Problem Report

Report Number: 5

Project Name: TeraPixel APS for CALICE

Item: Crosstalk/coupling effects

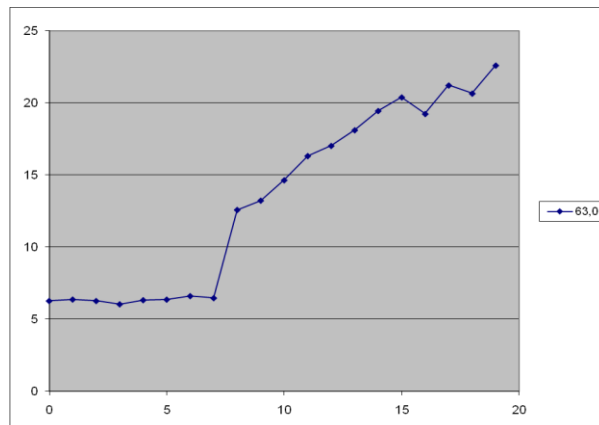
Crosstalk/coupling is observed when the whole sensor is enabled – this is generally evident in the threshold scan of pixels, which show a broadening of the threshold scan when other pixels are enabled.

Plot shows (y axis) the RMS of the threshold scan of a single pixel (ie whether it is narrow or broad) versus the number of rows that are enabled (x axis). For each enabled row, 42 pixels become active; the location of the 42 enabled pixels each time is random, indicating the effect is global, not a local neighbour effect.

For this particular sensor the tripping point is between ($7*42=294$) and ($8*42=336$) active pixels, but it tends to vary somewhat between different sensors.

By shifting the trim of the pixel that we are interested in, it can be shown that the threshold scan of that pixel remains the same, but is buried under all the extra false hits caused by other pixels firing somewhere in the array.

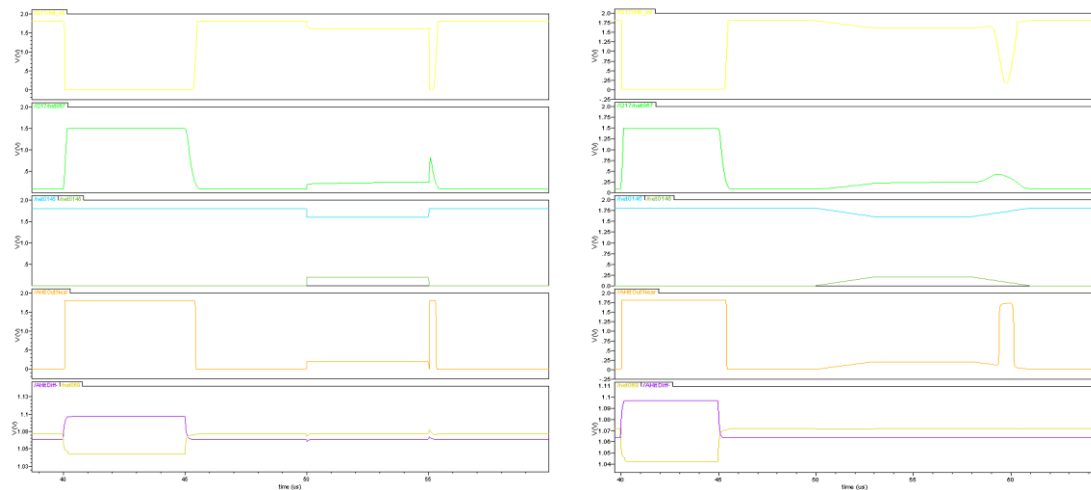
Suspect that the dominant current drain is due to monostables firing (which draw ~10uA each, so estimating the tripping current of ~3mA in a sensor region) . The monostables share a power net with one of the in-pixel comparators – when enough fire the droop in this power supply is thought to cause comparators to “fire” in sympathy.....

Simulations below demonstrate that 200mV droop in VDD (and complimentary rise in VSS) can trigger an artificial “hit” output when the power net is changing potential - whether fast [5ns, left] or slow [3us, right] transient on power lines.

For TPAC1.1 & future revisions recommend VDD1V8dco is separated such that comparators have a dedicated power net, and the monostable power is separated such that this method for coupling is eliminated.
